ADDENDUM NO. 1

CITY OF DEL MAR POWERHOUSE PARK TOT LOT RENOVATION PROJECT

August 25, 2022

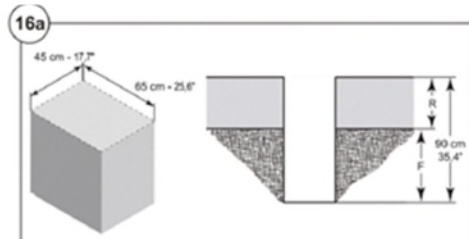
Question 4: The foundation hole as shown in the Appendix is 17.7"x 25.6" as show below, can we make it as a hole 24" diameter?

Response: Yes.
